# Value Engineering Workshop Report

## US 41 - North Main Street Kentucky Transportation Cabinet

**Workshop Dates: August 16 - 20, 2021**

**September 3, 2021**

**TITLE** Alternative 5 – (Tweaks to Alternative #2)

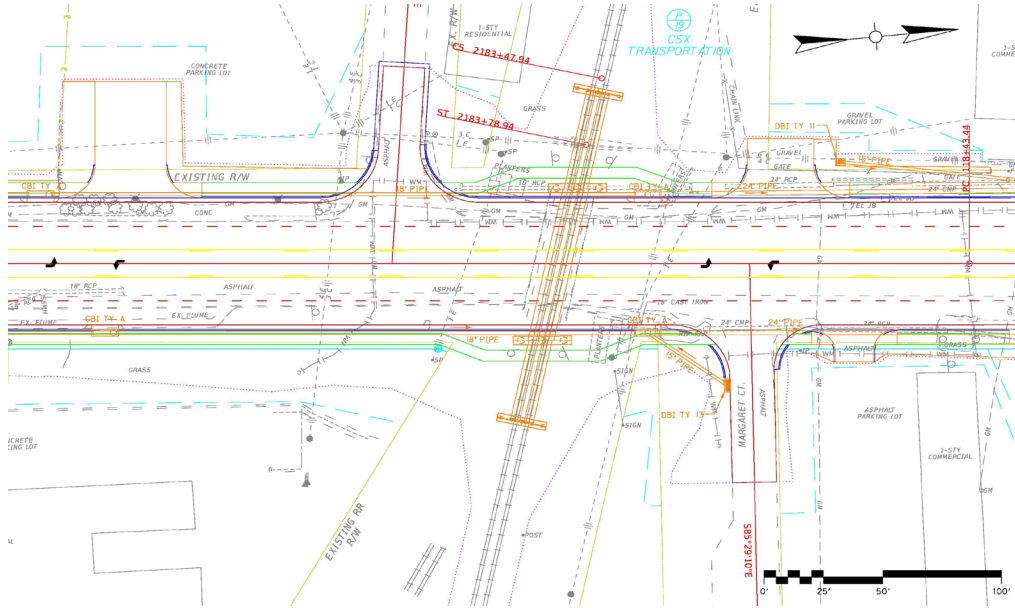
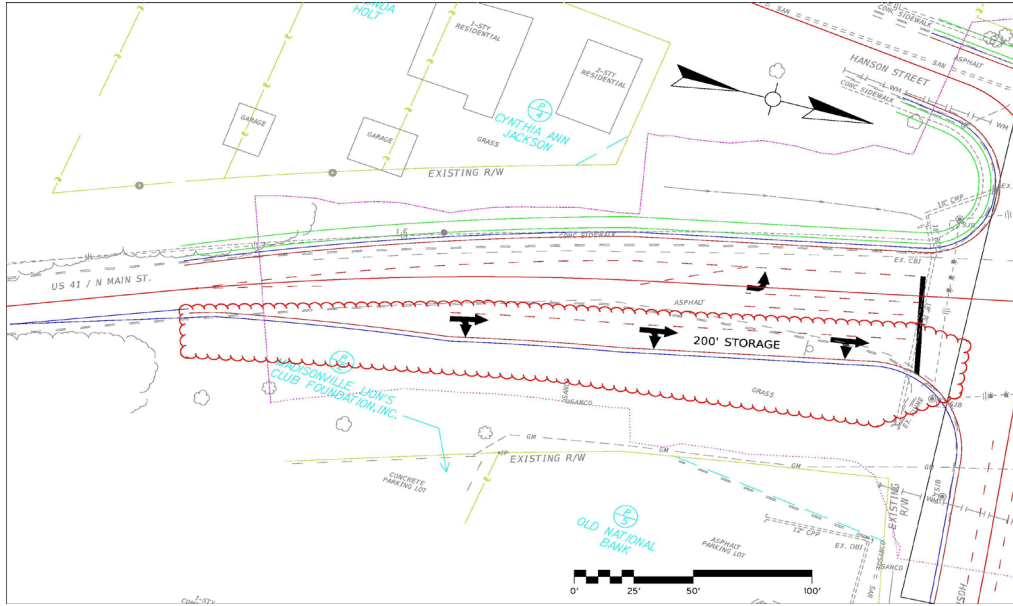
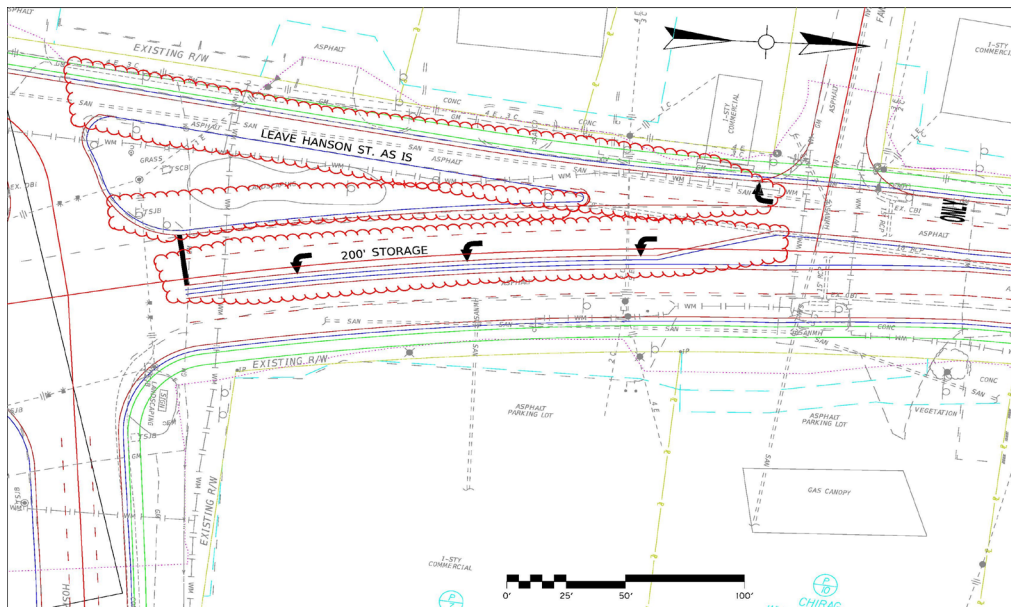
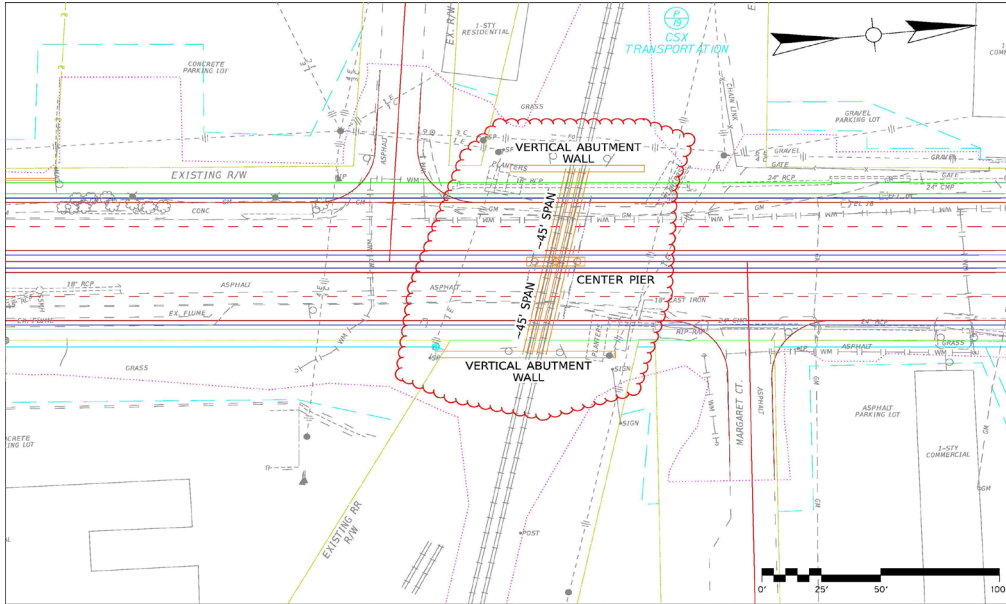
The baseline proposal has 3 span structure with a 71 ft main span over the roadway that includes a 5 ft sidewalk on each side.

Alt. 5 proposes the extension of the NB RT/ thru lane onto Hospital Dr. (above) 125 ft (making the final storage 200 ft). In the photo below, Alt. 5 proposes extended the LTL onto Hospital Dr. 110 (making the final storage 200 ft as well). Alt. 5 proposes to leave Hanson Street open (using it as a lane-drop location for the right lane (SB on US 41)). This eliminates the need for the SB RTL at Hospital Dr as in the baseline.

Alt. 5 proposes a 2 span structure with 45 ft spans and a center pier and vertical abutment walls.

**TITLE** Replace signals with roundabouts and use quick-curb between intersections

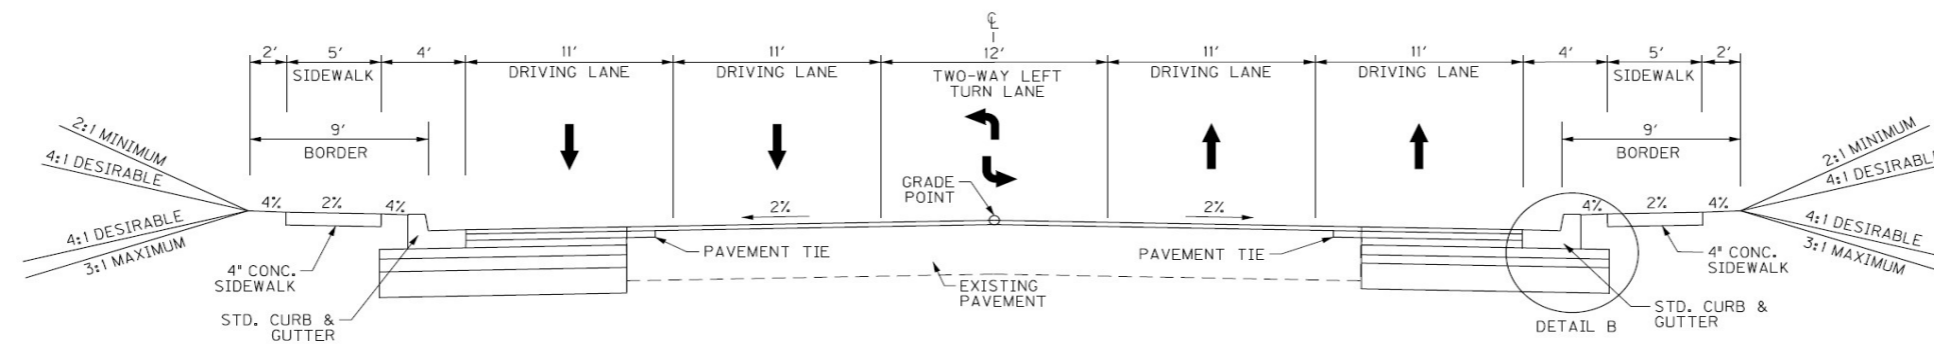
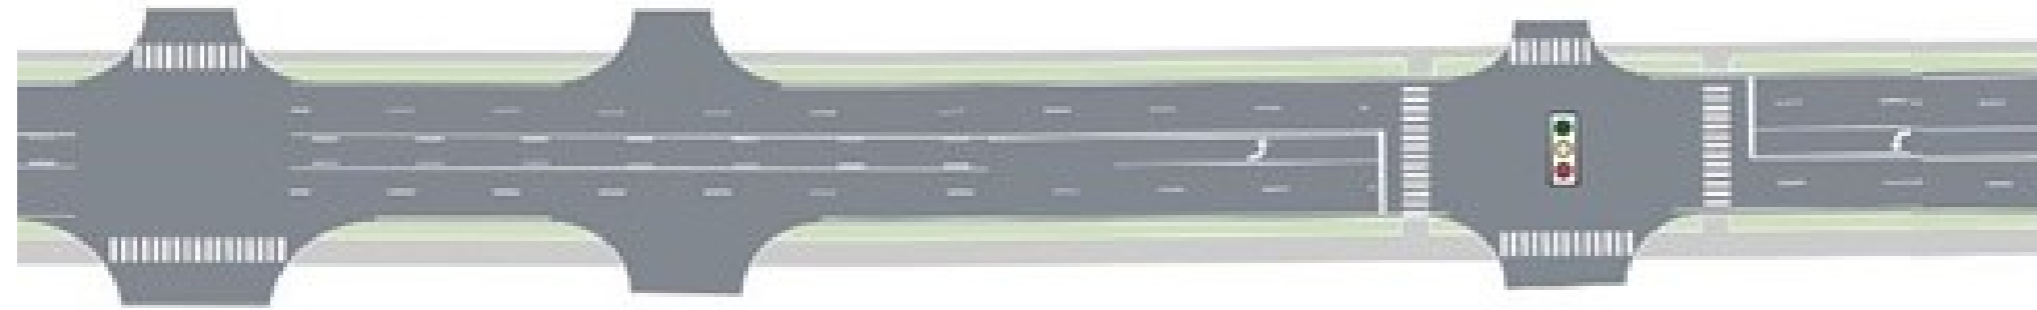
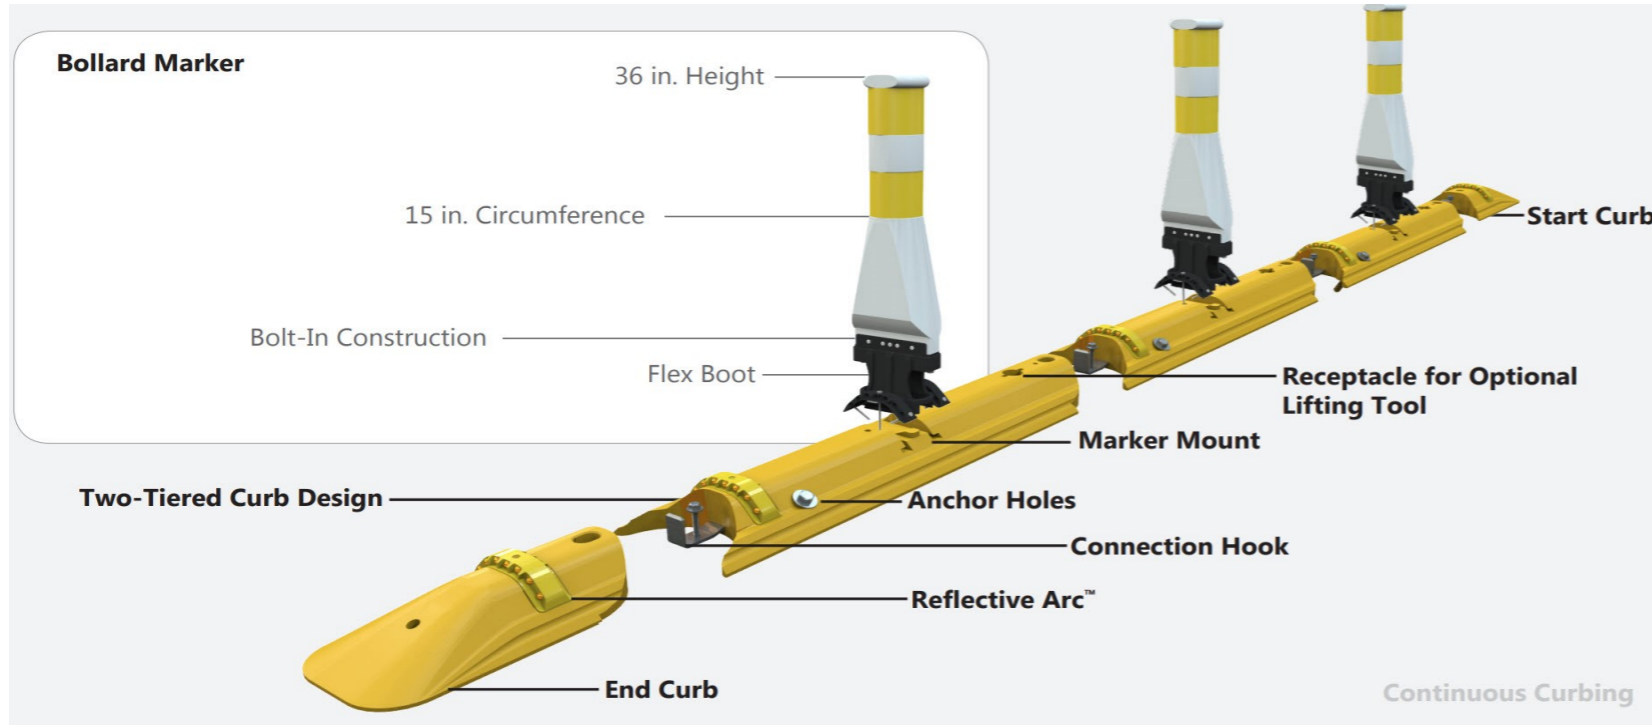
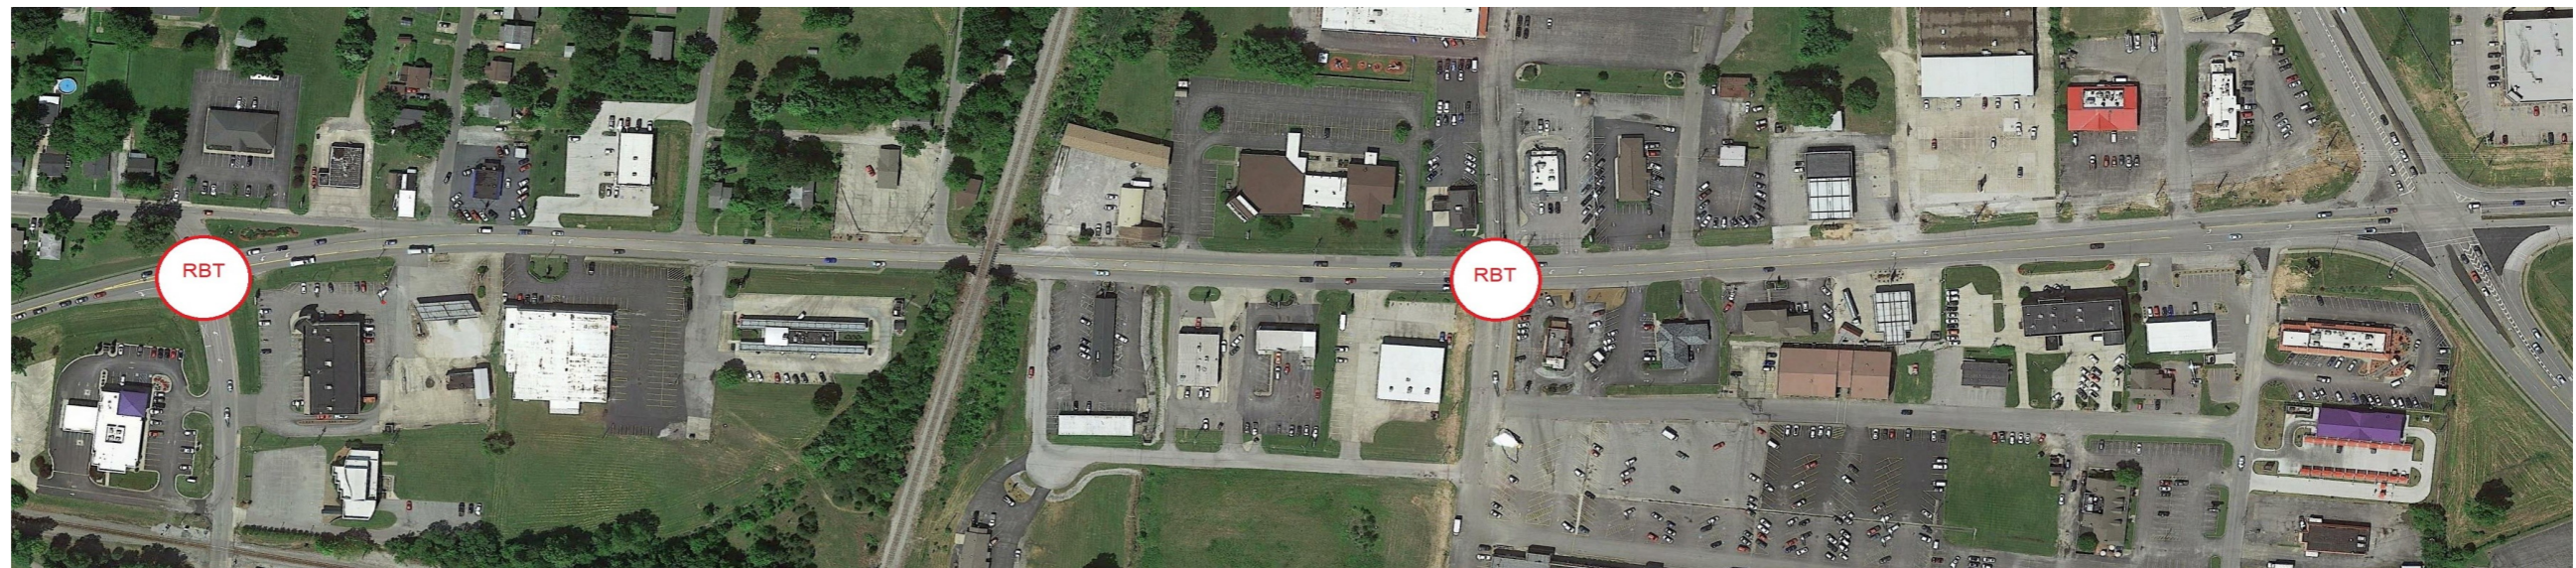
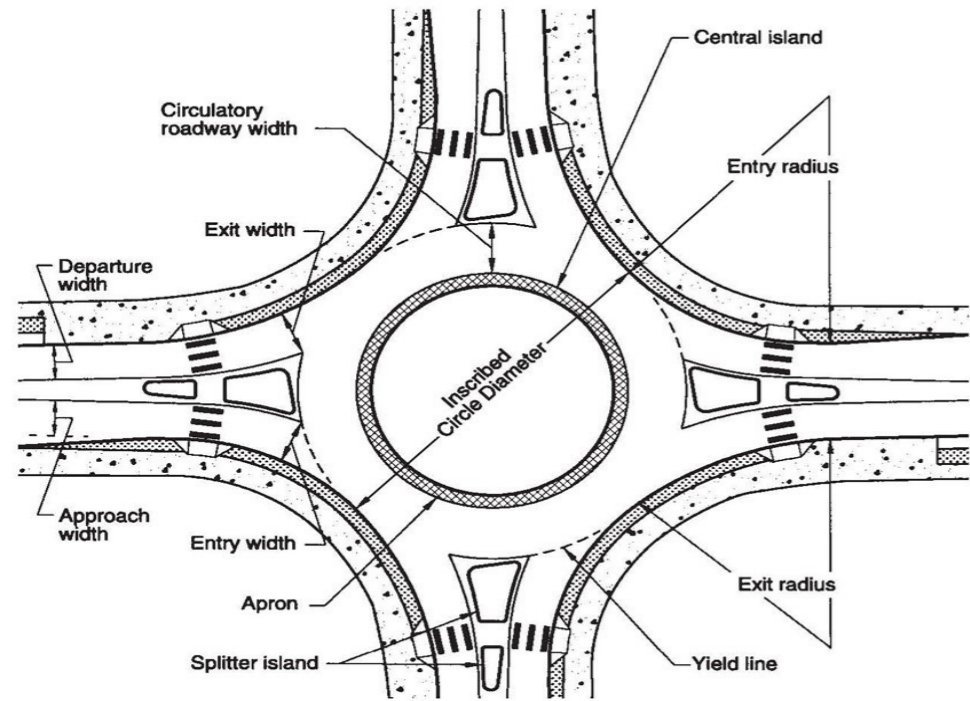
<b>TITLE</b>	Replace signals with roundabouts and use quick-curb between intersections		
<b>FUNCTION</b>			
<b>BASELINE ASSUMPTION:</b>			
The baseline, Alternative 1, includes a 5 lane cross section with traffic signals replaced at Hospital Drive and Briarwood Drive and a TWLTL in middle with no left turn restrictions.			
<b>PROPOSED ALTERNATIVE:</b>			
This proposal replaces traffic signals with single lane roundabouts. Narrow center median from 12 feet to 2 feet and install quick-kurb (lane separator system). No other improvements. This would be a more minimalistic approach to the design.			
<b>BENEFITS</b>		<b>RISKS/CHALLENGES</b>	
● Improves intersection capacity and efficiency		● Public acceptance	
● Reduces crash rates at intersections and mid-block		● At the two intersections, significant construction and Right of Way cost compared to signals	
● Does not replace RR bridge		● No pedestrian accommodation along the roadway or Railroad underpass

<b>TITLE</b>	Replace signals with roundabouts and use quick-curb between intersections
<b>DISCUSSION/JUSTIFICATION:</b>	
<p>This proposal, unlike Alternative 4, would be a relatively minimalistic approach to this project to reduce congestion and reduce crashes. This approach to the project will not include sidewalks, railroad bridge replacement, or backage road circulation improvements. It is entirely focused on two main problems US 41 is experiencing; a high crash rate due in part to frequent left turns and long roadway queues due to single lane intersection capacity, using traffic signal control. This alternative allows project phasing. Each roundabout can be designed and constructed separately if desirable. The centerline quick-curb would not be installed until both roundabouts were available to support U-turns. Roundabouts support U-turns of larger vehicles, whereas the proposed loons only accommodate passenger vehicles. This alternative would not interfere with improving the US 41 roadway to 2 lanes with median and pedestrian accommodation at a future time.</p> <p>Absent a widening project as proposed in Alternative 1, there will be room on the outside of the current pavement to build sidewalks.</p>
